ADDENDUM NO. One

Date: **September 29th, 2020**

Project Name: **Cepeda Branch Library Renovations**

C.I.P. No. **6014.041** Solicitation No.: **CSP6100 CLMC792**

1 FFE PLAN
SCALE: 3/16" = 1'-0"
NOTE: THIS SHEET IS INCLUDED FOR COORDINATION PURPOSES ONLY - FFE NOT IN CONTRACT - AS NOTED 'N.I.C.'

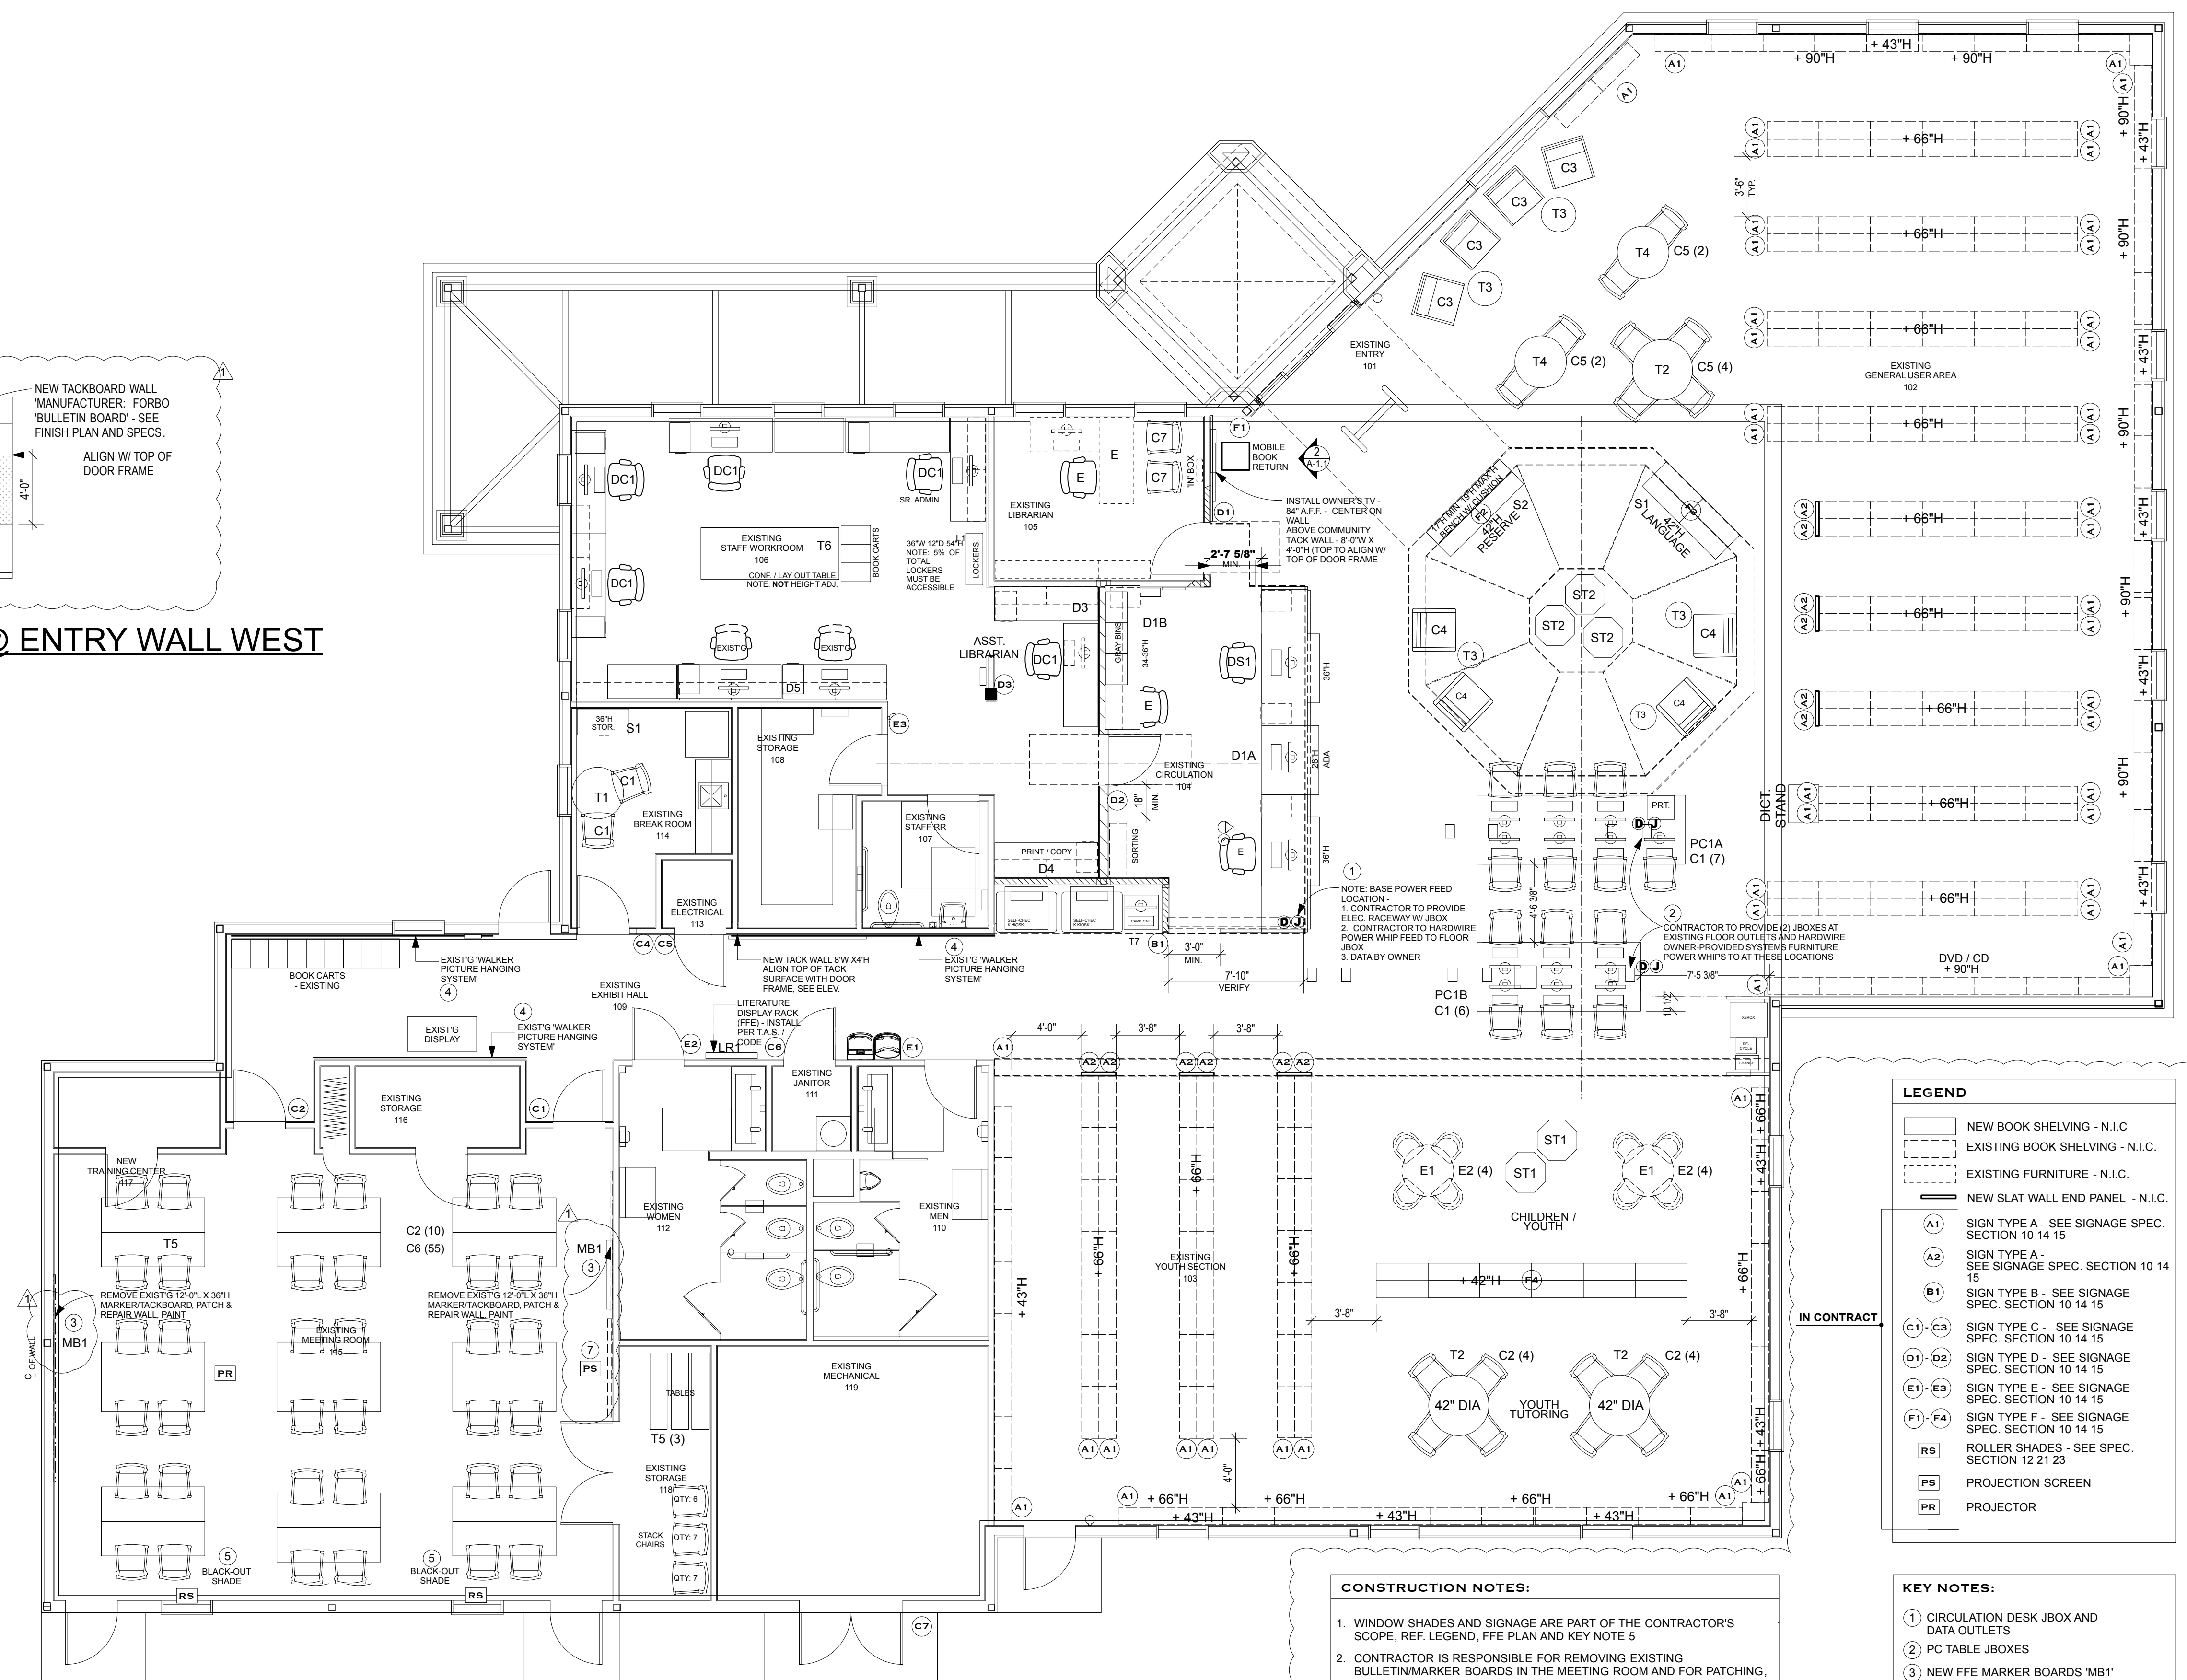
- Item 3. **On Sheet A-1.1 - Furniture Plan:** Note Revisions are made on Enlarged Restroom Plans (1/A-1.1) and tagged Revision 1.

- Item 4. **On Sheet A-1.1 - Furniture Plan:** See revisions to the Legend, Key Notes and Construction Notes, and Interior Elevation (2/A-1.1); all tagged Revision 1.

2 ENLARGED PLAN: 107 STAFF
SCALE: 3/8" = 1'-0"

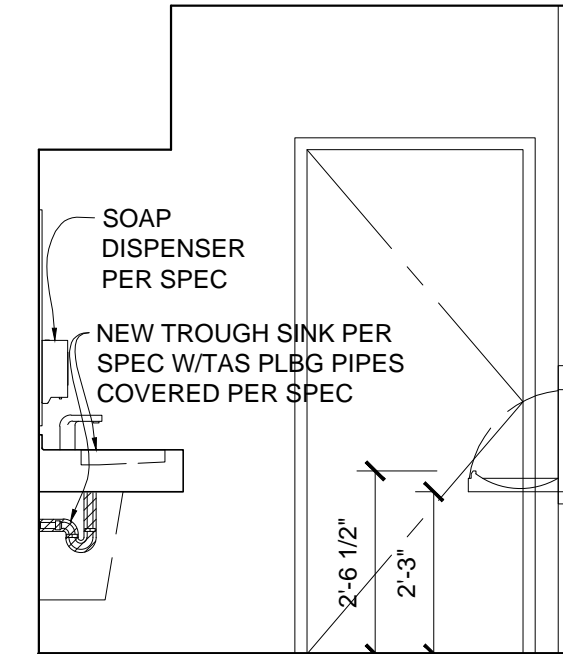
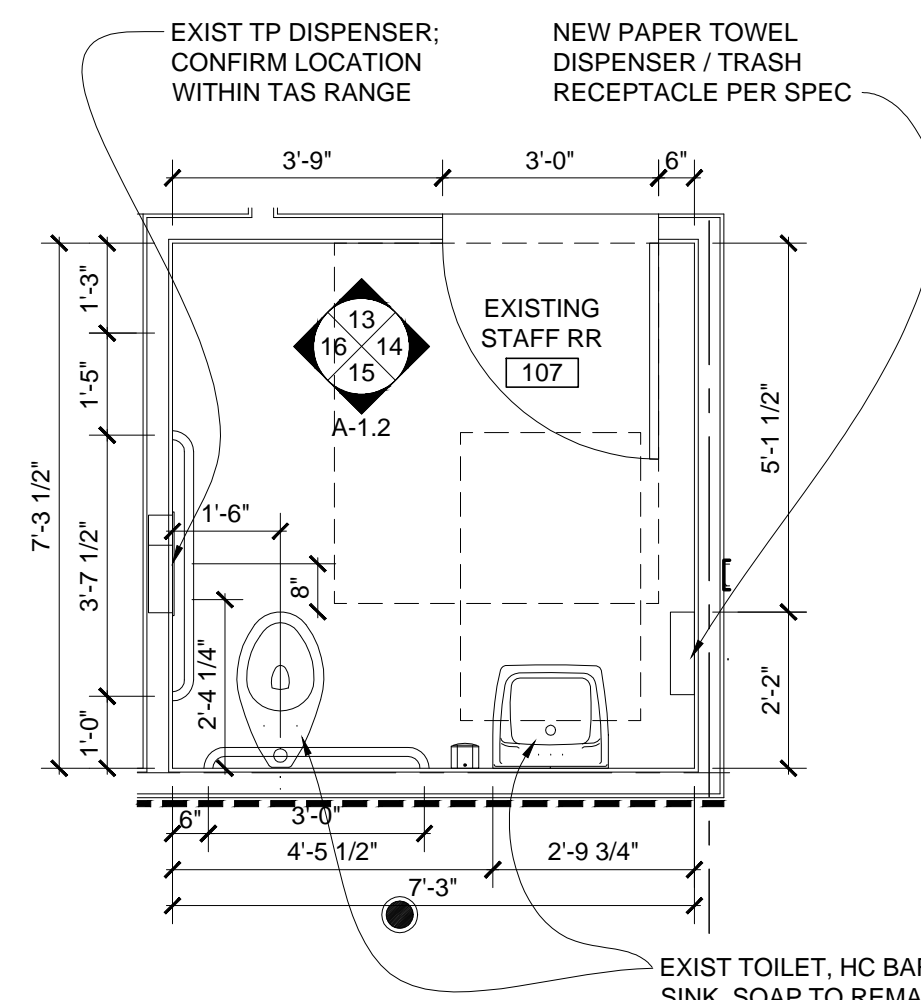
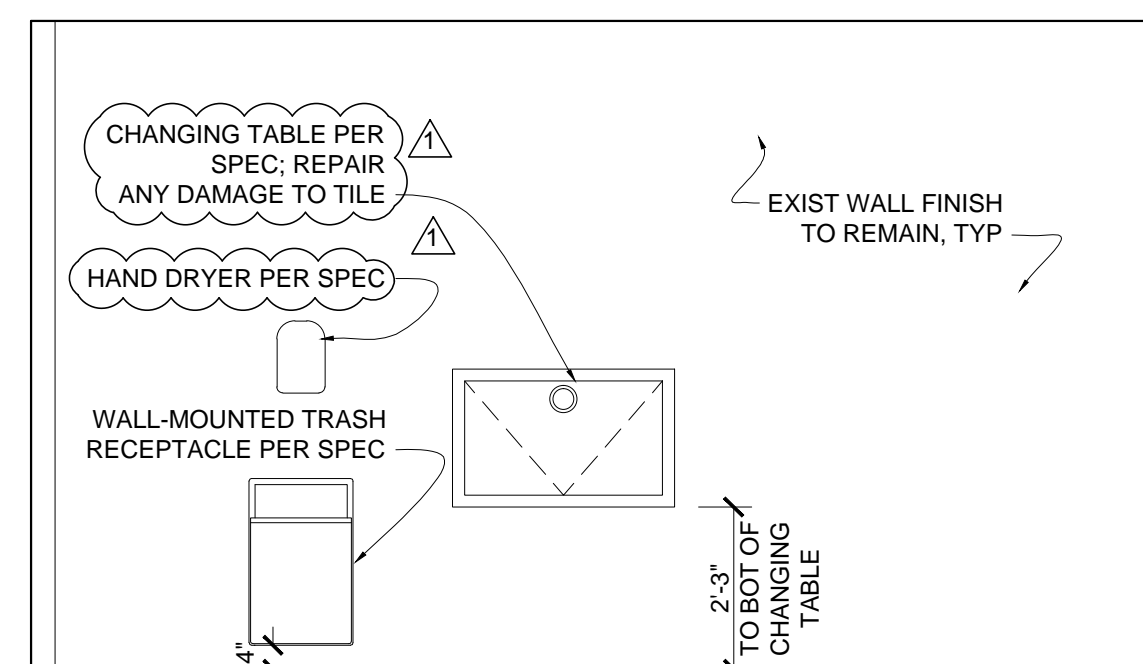
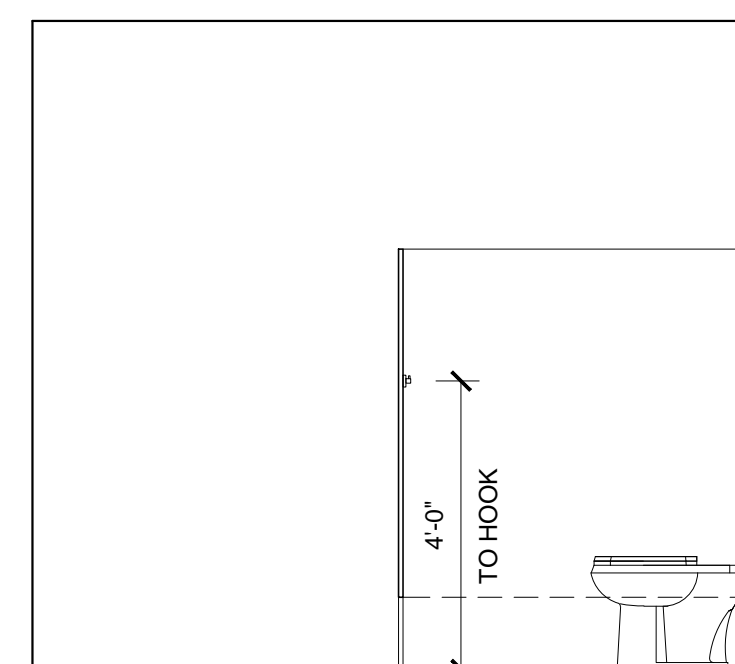
- Item 5. **On Sheet A-1.2 - Enlarged Restroom Plans:** Note Revisions are made on Enlarged Restroom Plans (1/A-1.1) and tagged Revision 1.

1 FINISH PLAN
0 4' 8'

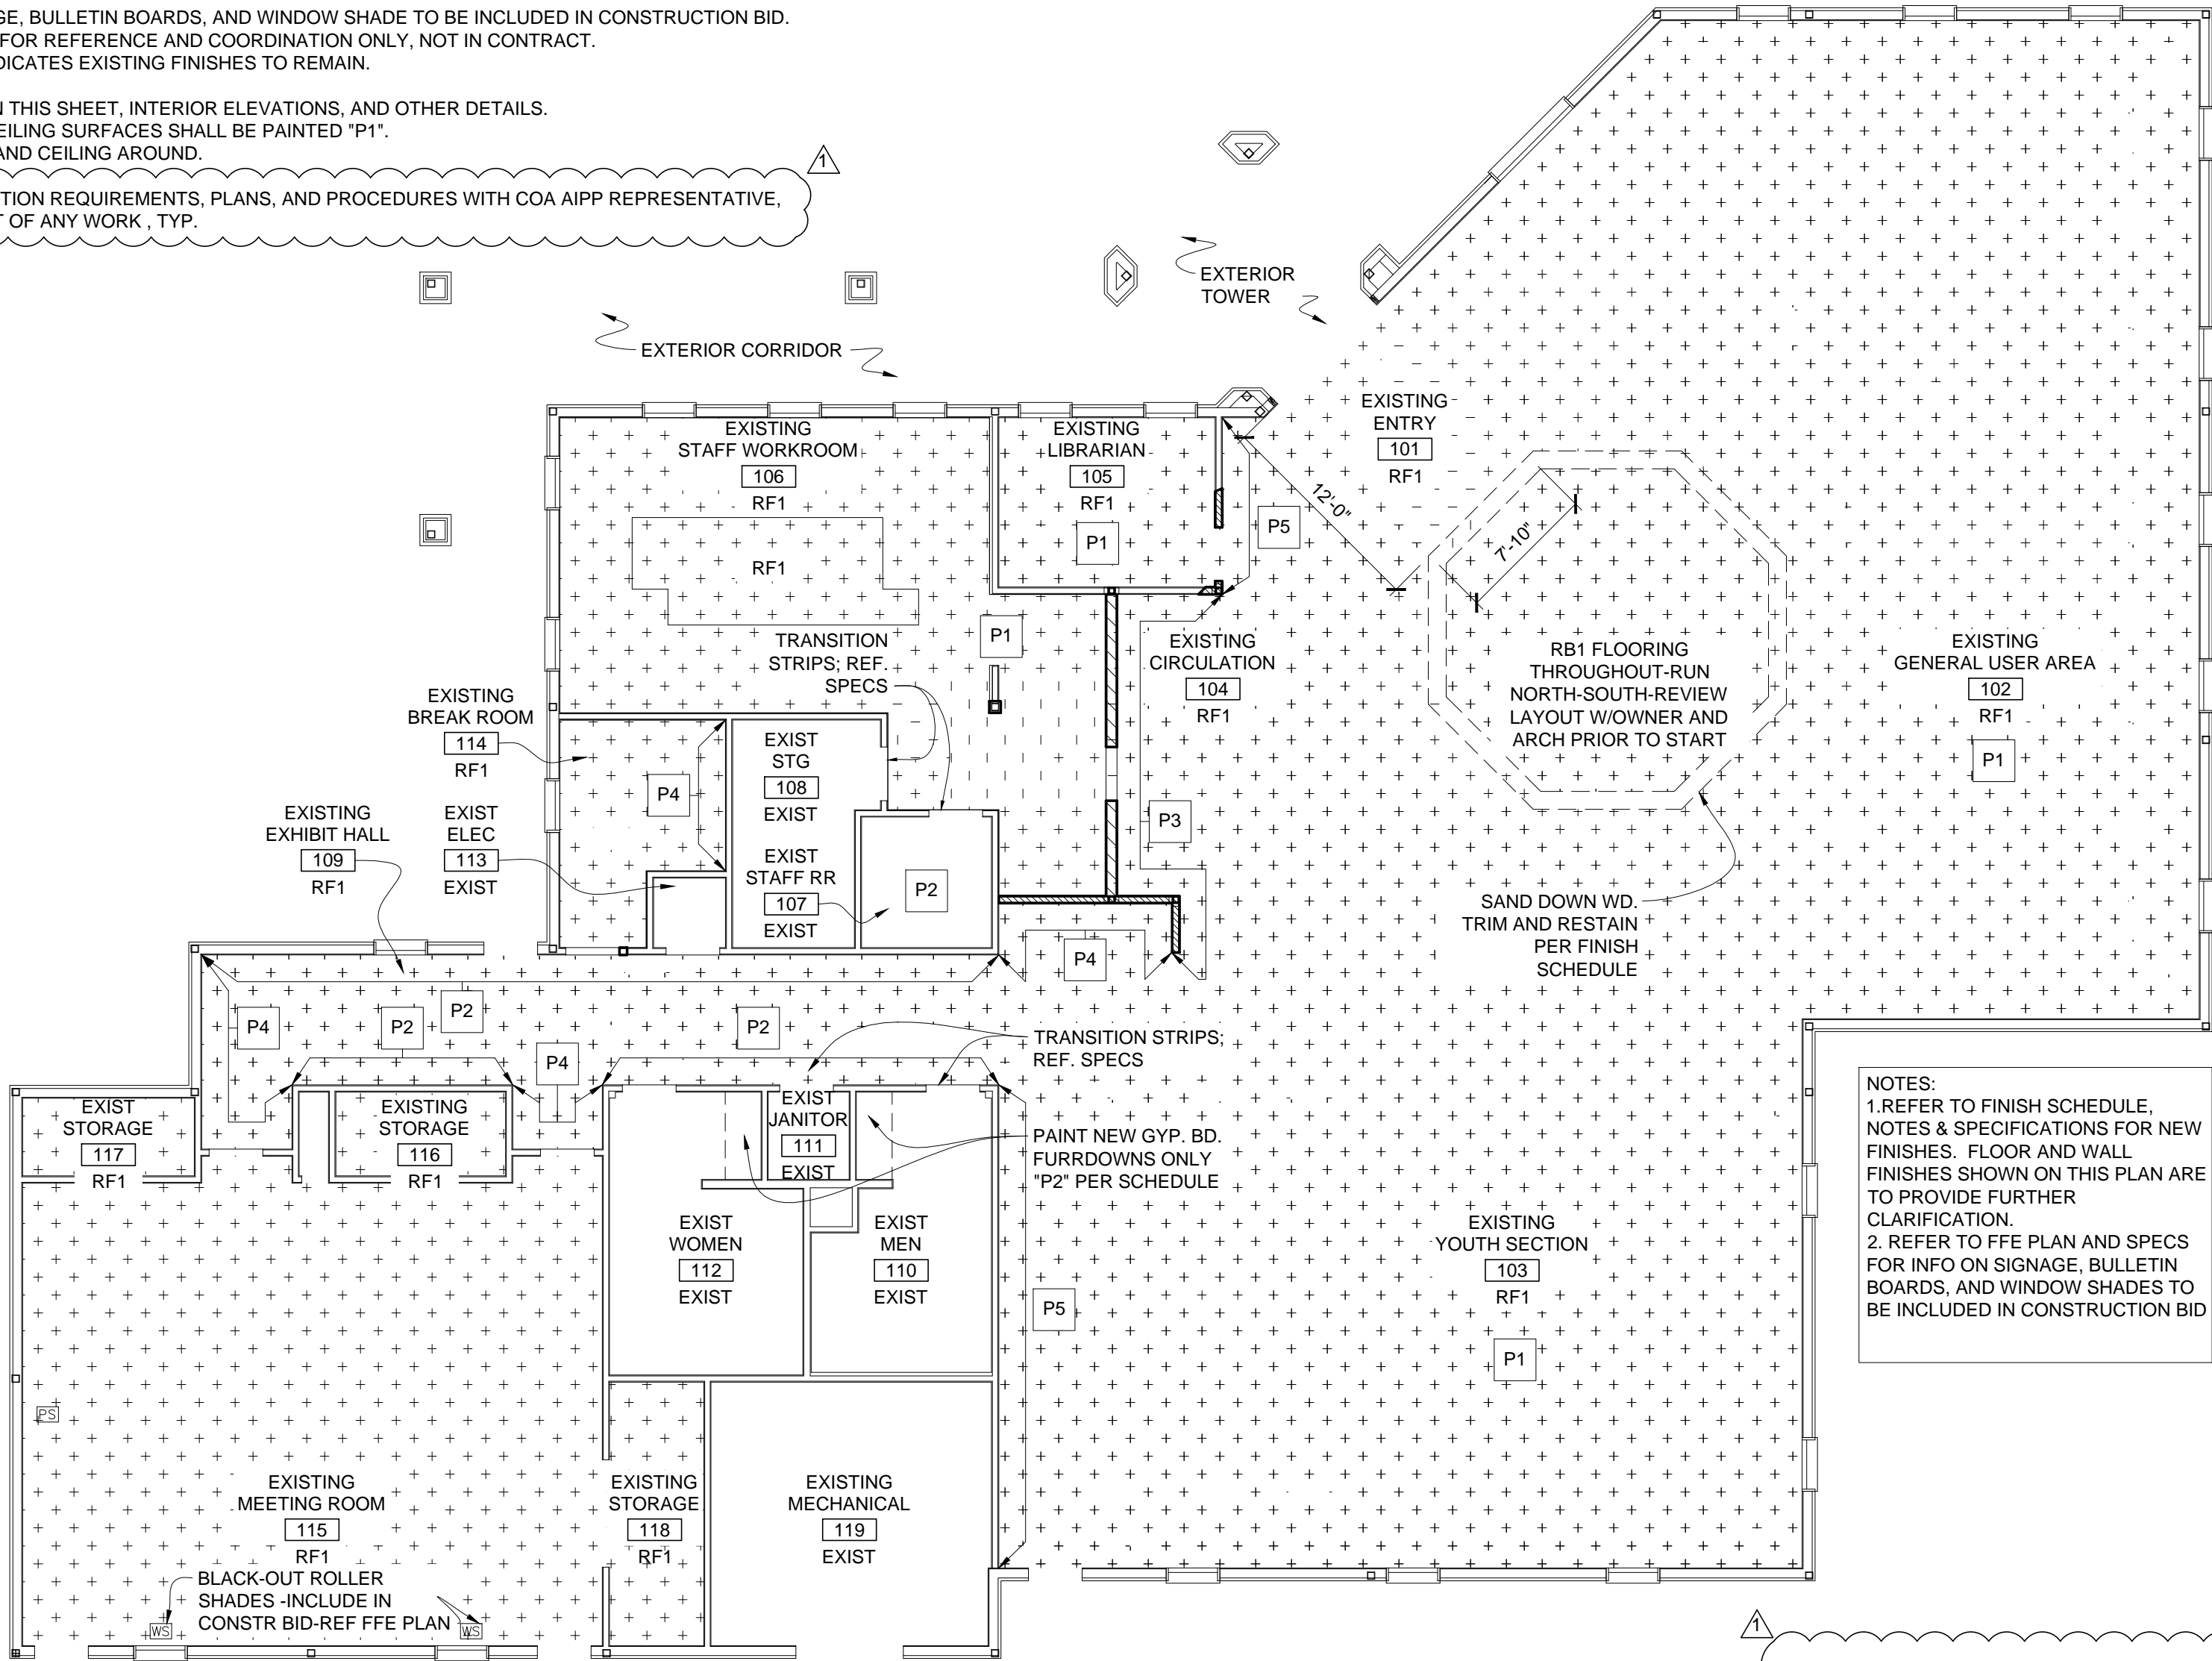
- Item 6. **On Sheet A-1.3 - Finish Plan & Schedules:** New Finish Schedule Note 7. is added and tagged Revision 1.

- Item 7. **On Sheet A-1.3 – Finish Plan & Schedules:** the drawing scale of the FINISH PLAN (1/A-1.3) is changed to 1/8" =1'-0" (from the former 1/16" =1'-0").
- Item 8. **On Sheet A-6.0 – Opening Schedules & Details:** the Door numbered 109A is removed from the DOOR SCHEDULE.
- Item 9. **On Sheet E-1.0 – Electrical Power Plan:** under KEYED NOTES: the note numbers 1, 2, and 3 are added.
- Item 10. **On Sheet E-2.0 – Electrical Lighting Plan:** the location of the New Lighting Control Panel is revised on the Plan (as per Keyed Note 1) and tagged Revision 1.
- Item 11. **On Sheet ED-2.0 – Electrical Lighting Demolition Plan:** the location of the existing Lighting Control Panel to be removed is revised on the Plan (as per Keyed Note 2) and tagged Revision 1.
